Access Compliance Report

Public Rights-of-Way

(Curb Ramps)

| Intersection ID: 9561 | Main Street: SELDON_DR | Cross Street: N/A | Location: S |

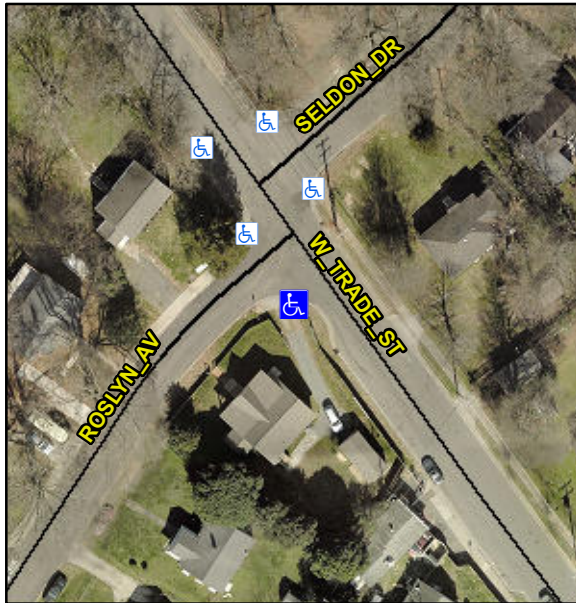
NO LT SW

Not Found, R304.5.3

| Compliance | Description | Data | Compliance | Description | Data |
|------------|-----------------------|-------|------------|-----------------------------|------|
| Yes | Ramp Width (in) | 75.0 | No | BlendTrans XSlope (%) | 6.4 |
| | | | No | Curb Slope (%) | 13.4 |

Remove & Replace Curb Ramp With Two New Directional Ramps or Equivalent.
